UNITED STATES
NUCLEAR REGULATORY COMMISSION
WASHINGTON, D. C. 20555

SUBJECT: SUMMARY OF MARCH 27, 1987 MEETING WITH BWR OWNERS
GROUP/IDCOR ON MARK I CONTAINMENTS

BWR OWNERS GROUP/IDCOR
RESPONSE TO FIFTEEN MARK I CONTAINMENT
RELATED QUESTIONS

DRAFT SUMMARY OF MARCH 27, 1987 MEETING WITH
BWR OWNERS GROUP/IDCOR ON MARK I CONTAINMENTS

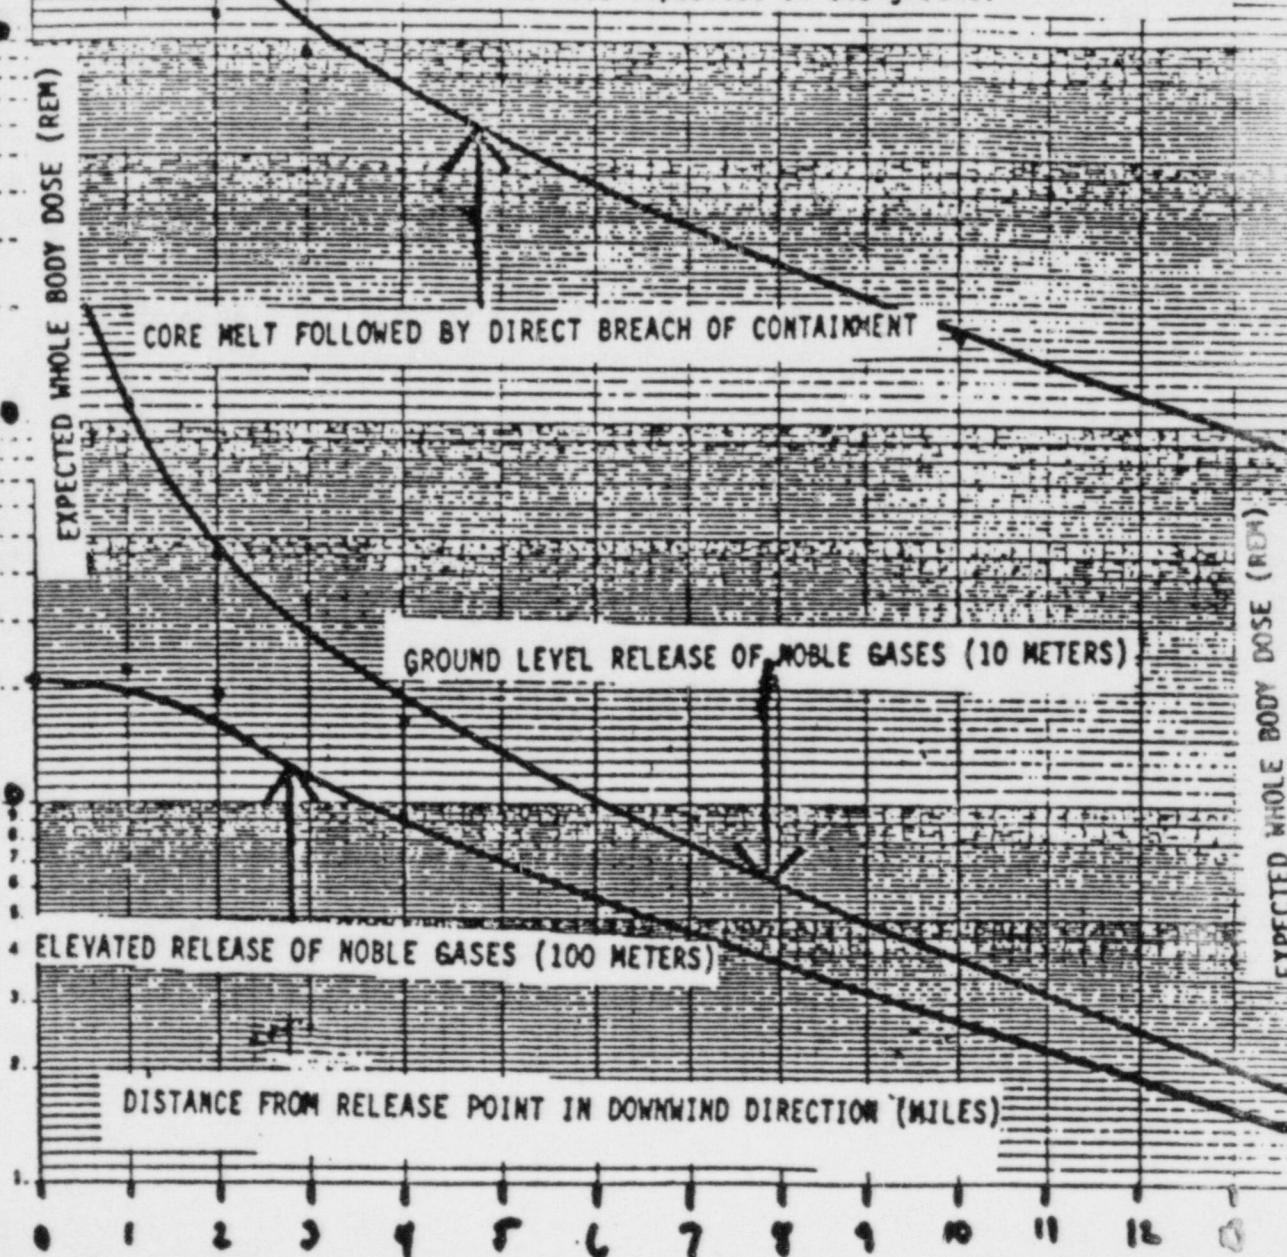
13. Calculations now available indicate that although noble gas doses can be high (see attached Figure) deliberate release of those gases appears to be better to avoid the far greater releases that might occur with an uncontrolled release. Do present models indicate that deliberate venting of noble gas activity may not be justified? (A. Diederich)

Figure D.4 Thermal history of the hottest steel node for various debris depths

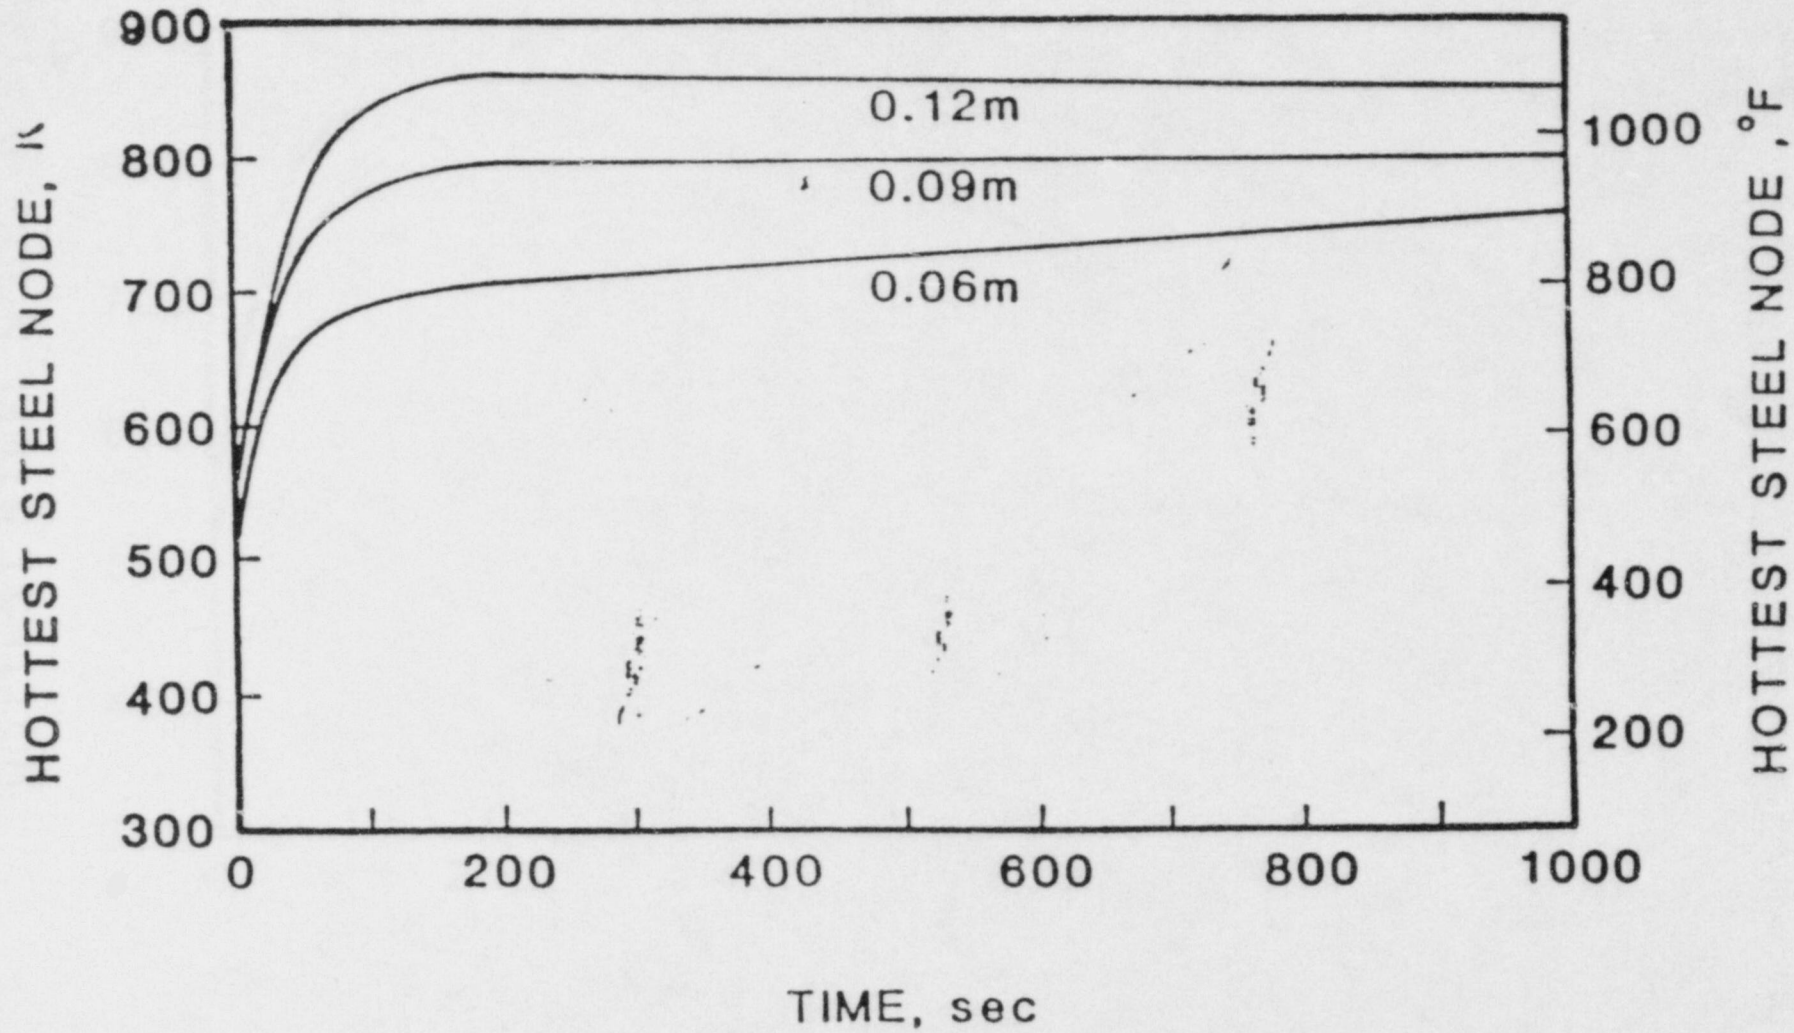
7. IS THE PRESENCE OF A ONE FOOT WATER LAYER ON THE DRYWELL FLOOR BENEFICIAL?

- O THE PRESENCE OF WATER WILL REDUCE:
 - POTENTIAL FOR DRYWELL WALL CONTACT
 - AIRBORN FISSION PRODUCTS THROUGH STEAM CONDENSING
- O ONE FOOT LAYER ALONE NOT SUFFICIENT - MUST BE REPLENISHED.
- O IDCOR ANALYSIS SHOWS:
 - PEAK WALL TEMPERATURE IS WELL BELOW THE STEEL MELT POINT FOLLOWING DEBRIS CONTACT
 - WATER LAYER SUBSTANTIALLY LOWERS THE WALL TEMPERATURE AND QUENCHES THE DEBRIS.
